ENVIRONMENTAL REVIEW TEAM REPORT

HARTLAND RECREATION AREA HARTLAND, CONNECTICUT

AUGUST, 1978

FIGURE 2
SURFICIAL GEOLOGY MAP

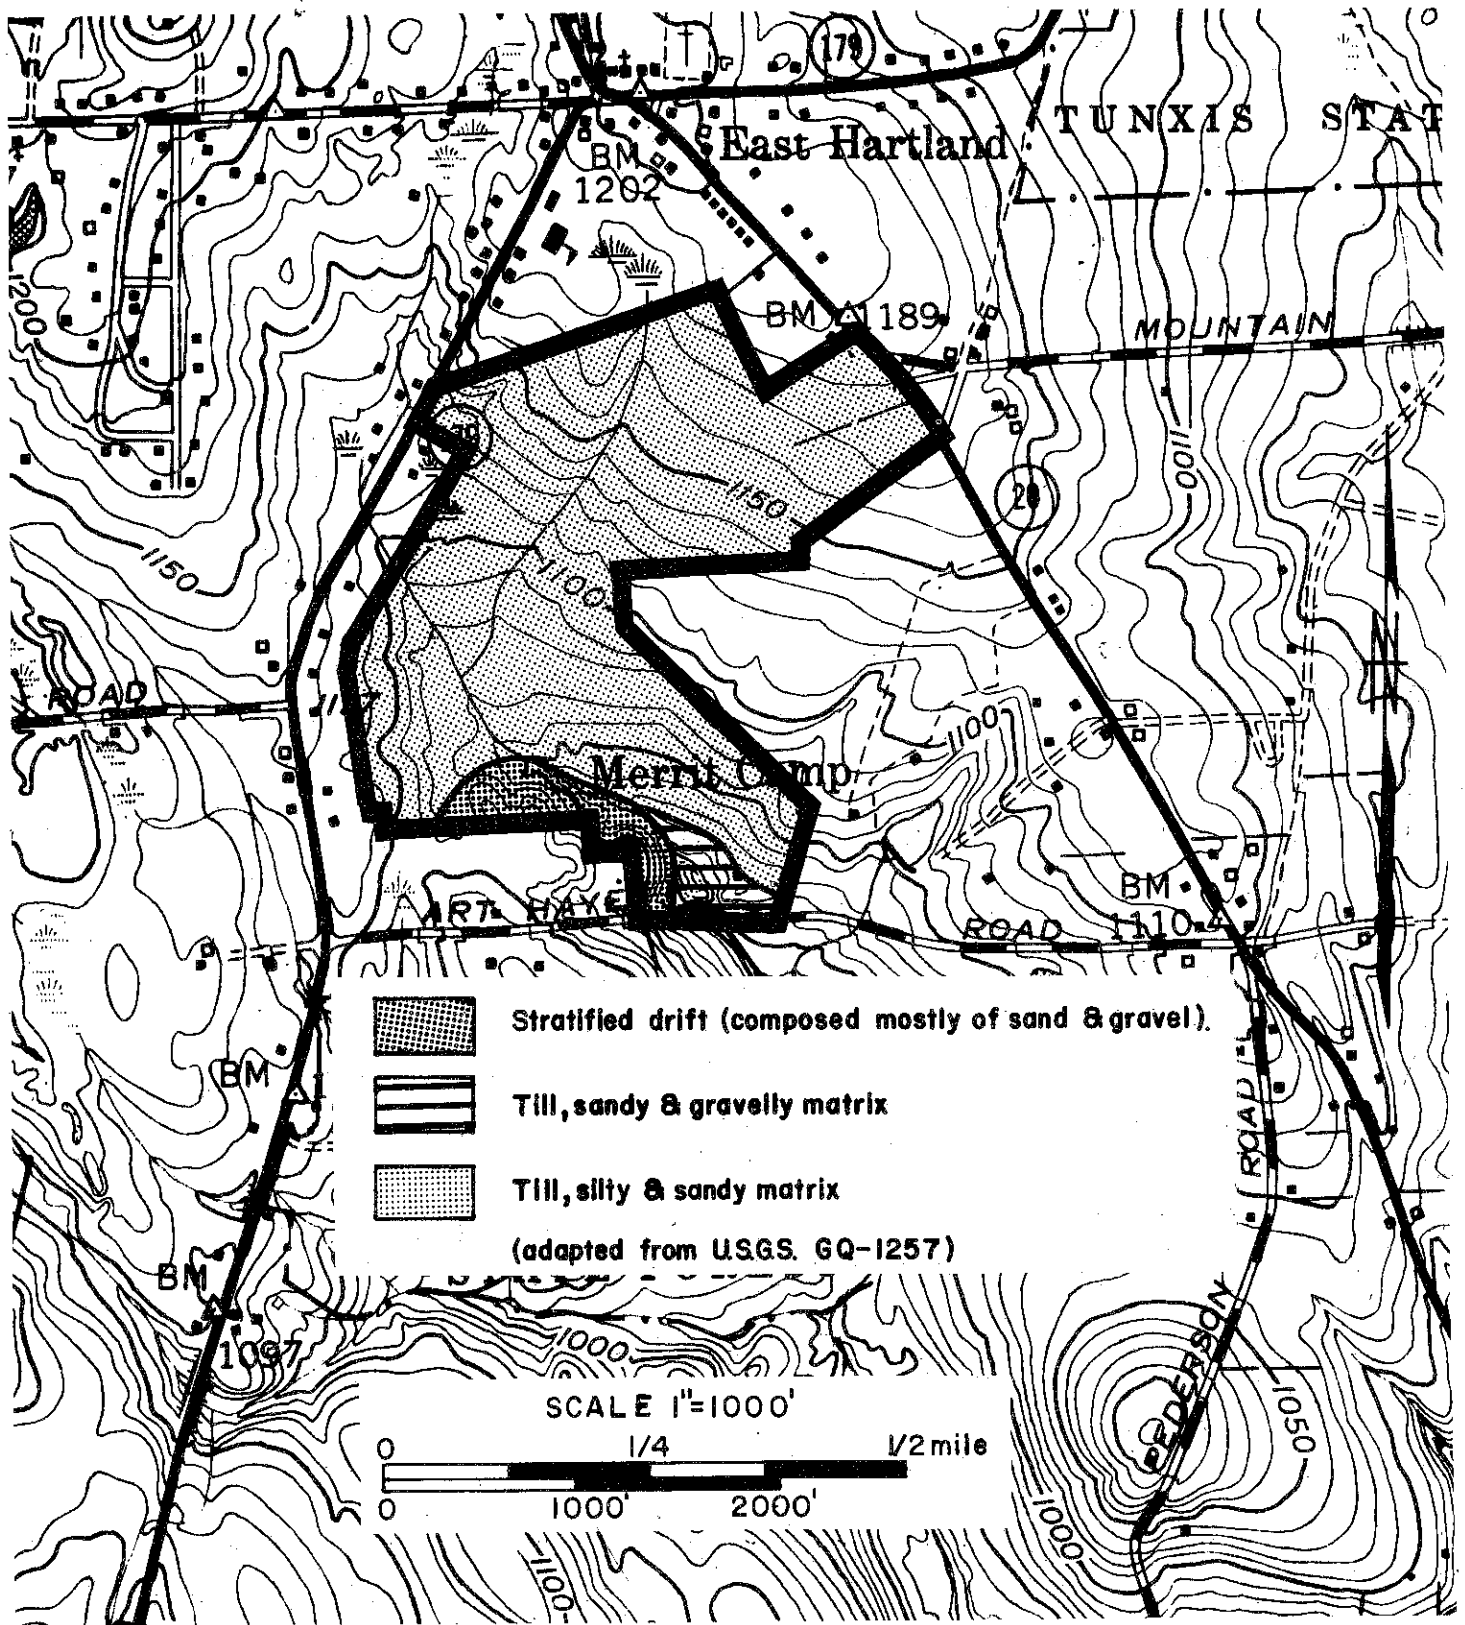
Although Figure 2 shows stratified drift on the property as being restricted to an area west of the pond, on-site inspections indicated that the till around the eastern shore of the pond is composed largely of sand and gravel as well. The meltwater from which the stratified drift was deposited apparently winnowed the finer rock particles from the adjoining till. Elsewhere on the property, the till is richer in silt and is less well-sorted.

FIGURE 3
WATERSHED MAP

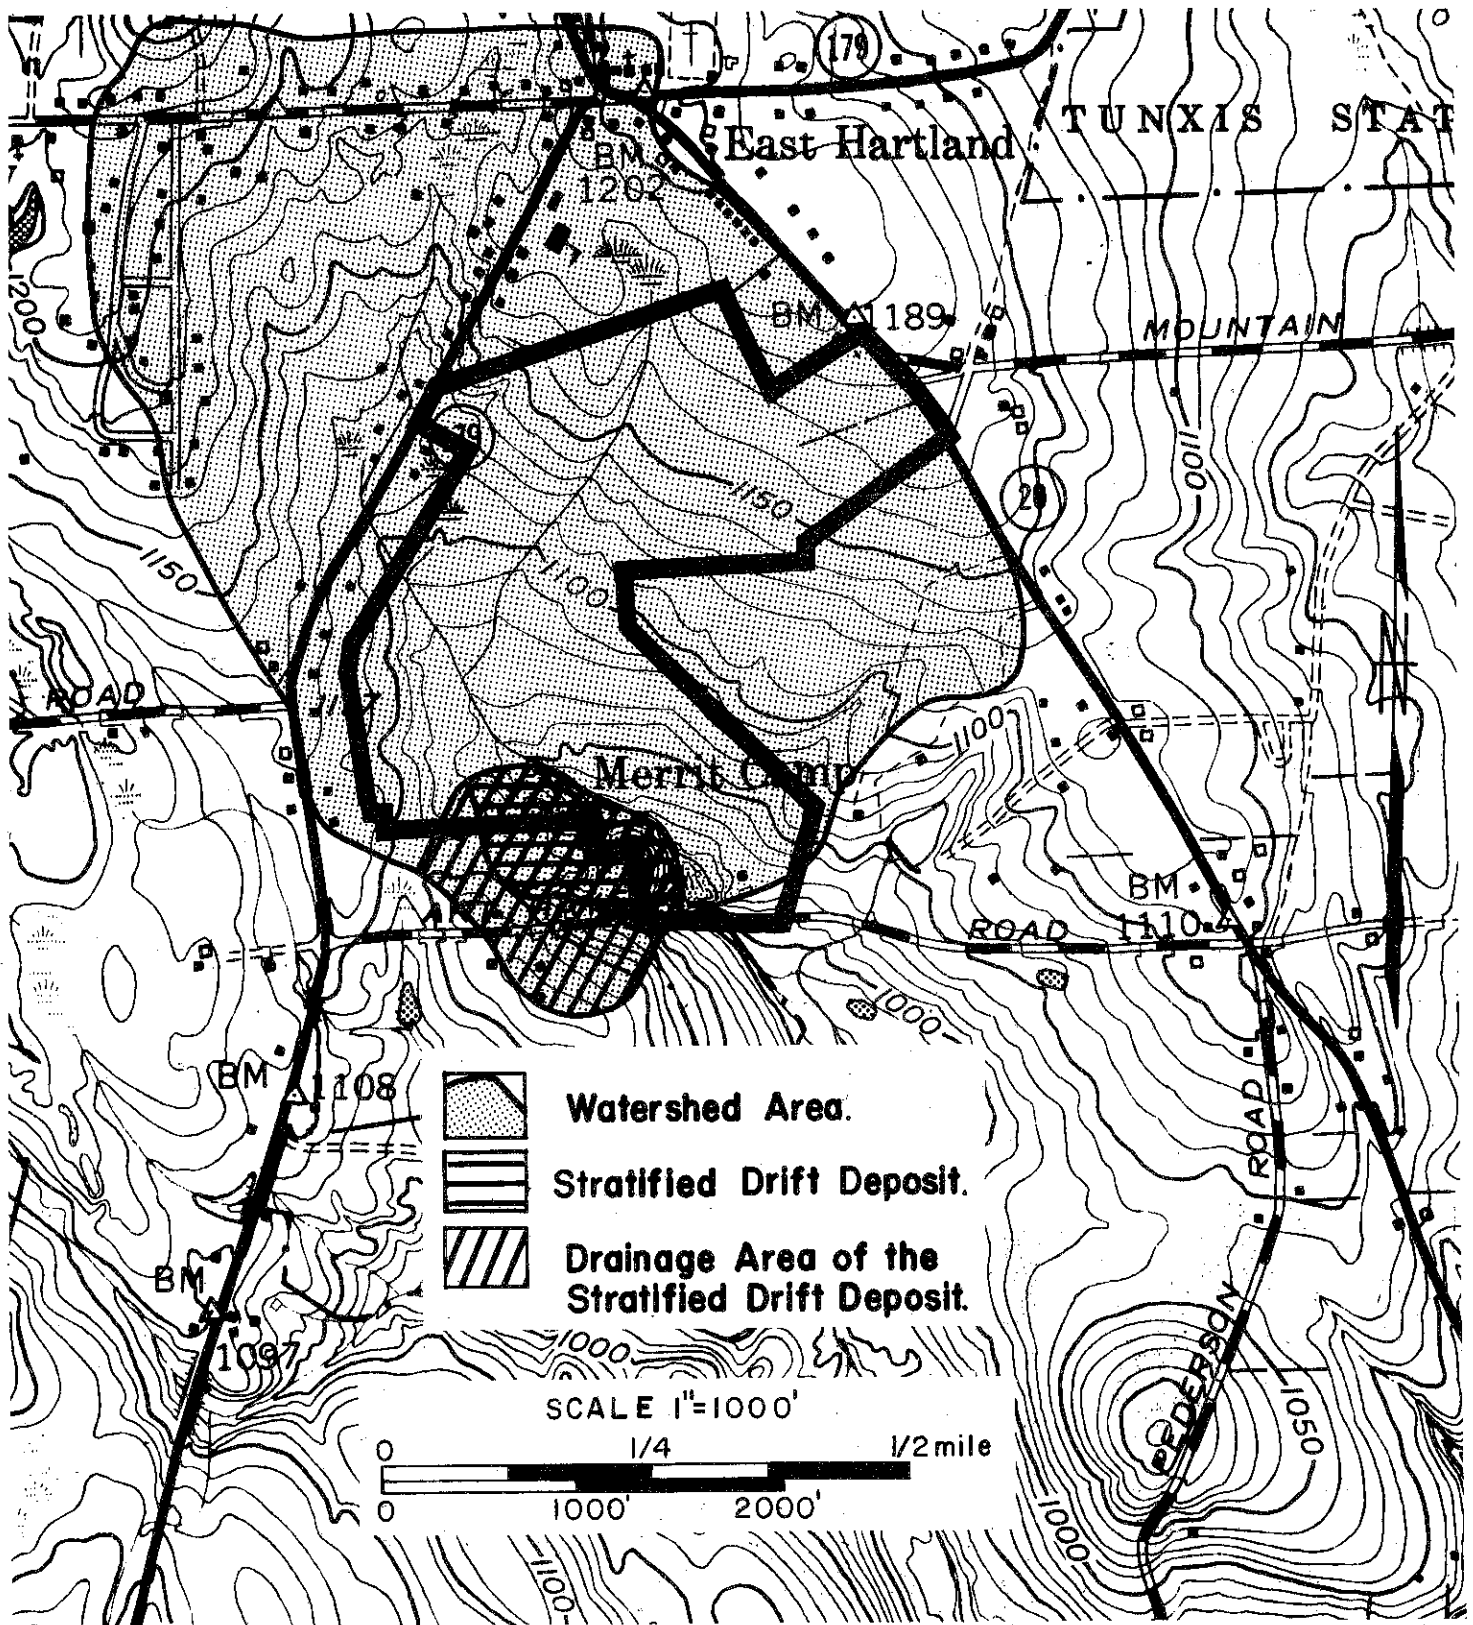
Virtually all surface-water runoff from the property, as well as part of the groundwater, flows toward the existing bathing pond. Runoff from some areas outside the property also flows toward the pond. In all, the watershed, or drainage area, that supplies runoff to the pond consists of approximately 365 acres (see Figure 3). Of this area, only 3 percent is covered by stratified drift. This is important because groundwater runoff from bodies of stratified drift generally is supplied to surface streams at a more even rate than is groundwater runoff from till. This phenomenon reflects the greater infiltration and storage capacity of the meltwater deposits. Because of these factors, streams in areas covered largely by stratified drift tend to experience much less variation in flow from wet seasons to dry than streams in till-covered areas.

The pond is about 1/2 acre in size and was dredged in recent years to a depth of approximately seven feet. The principal spillway is a concrete drop inlet structure with splash boards for regulating the pond water level. This spillway is located on the southeastern corner of the pond just north of the dam. On the day of the ERT field review, water was not flowing through the principal spillway but rather over the concrete weir emergency spillway on the west side of the pond. Splash boards installed at the principal spillway have raised the water level to the point where the emergency spillway is functioning instead of the principal spillway. This condition should be corrected for safety reasons. In addition, water outflow over the emergency spillway results in the shortest distance of travel through the pond from inflow to outflow. As a result, water flow does not go by the beach area and important water pollution dilution functions are lost.

In light of this situation, it is suggested that both dam and emergency spillway elevations be raised. By raising the emergency spillway, the principal spillway could function at the existing water elevation. This is advantageous for safety reasons and in addition, water flow would be directed through the center of the pond and closer to the beach area.

FIGURE 4
VEGETATION TYPES

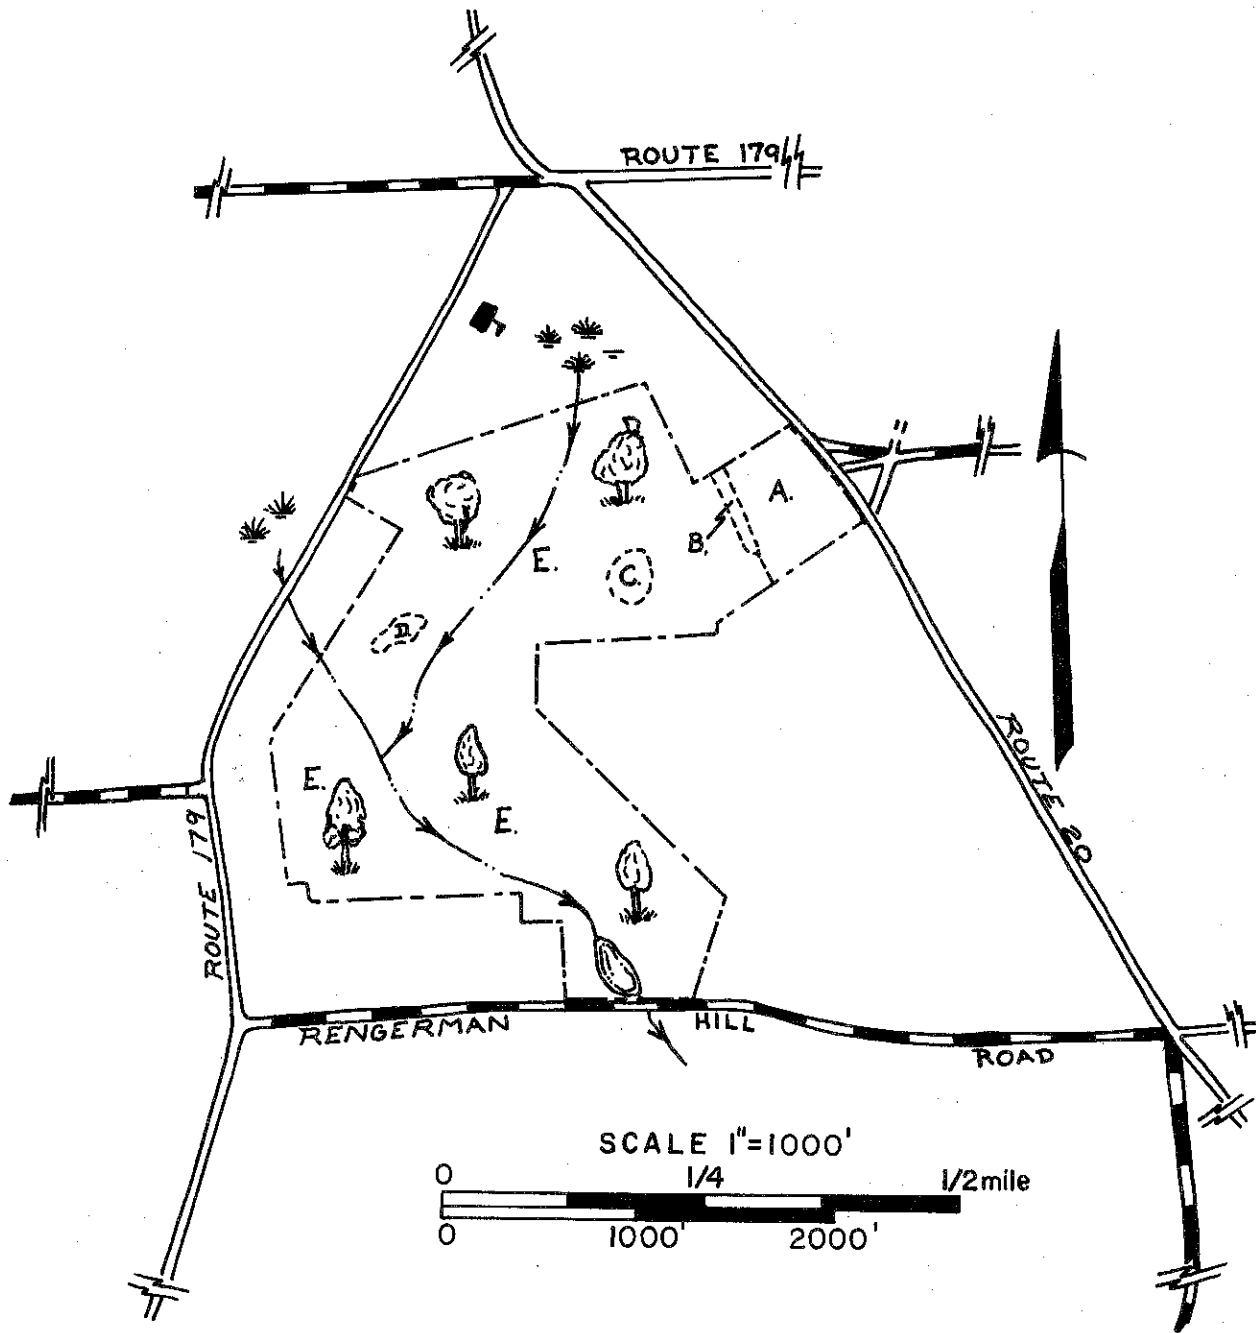
The tree species on the site are typical of the region. Hemlock, beech, red maple, and red oak are abundant. White pine, white ash, yellow and black birch, and hophornbeam are common. Witchhazel, mountain laurel, and beech sprouts form a "brushy" understory. Of particular aesthetic value are small groves of white pine and beech, which have a more open, park-like appearance, and one exceptionally large red maple (see Figure 4).

Trails constructed through several small groves of the larger trees and across the stream would have high aesthetic appeal for hikers and skiers. In wet areas, corduroy or split-log bridging will be necessary on year-round trails to prevent rutting, soil compaction, and root damage.

FIGURE 5
SKETCH SITE PLAN

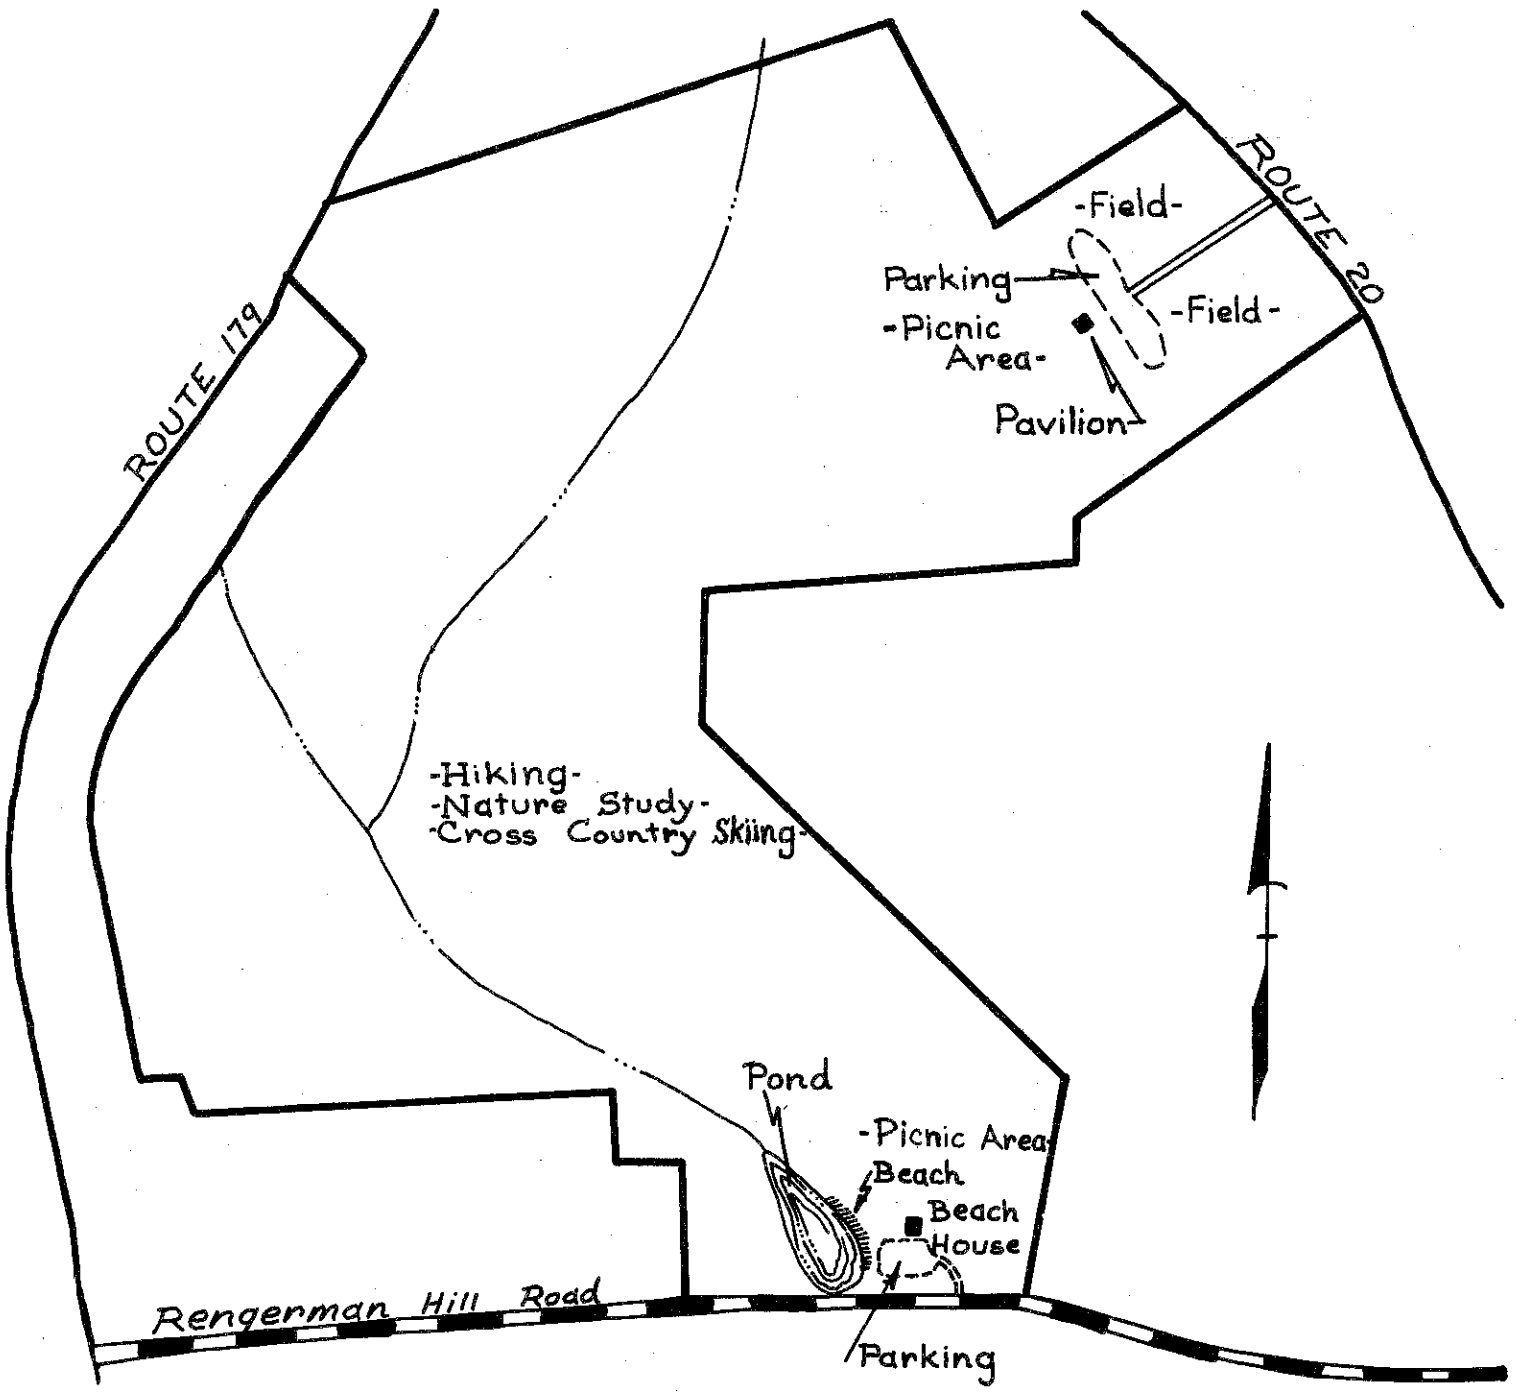
With development of this area for active recreational use, a road and parking lot is recommended to service the area. One alternative development plan would consist of a road bisecting the property leaving ample space for two ballfields, one on each side of the road (see Figure 5). This road would branch into two parking areas capable of handling thirty cars each. This parking area should provide enough spaces for baseball use and could also service a picnic area if developed behind the baseball fields (see Figure 5). Development of a picnic area is suggested here as the red pine grove in this area is of high aesthetic value and would make a nice picnicking spot. Although this spot is scenic, it may prove to be wet in the spring.
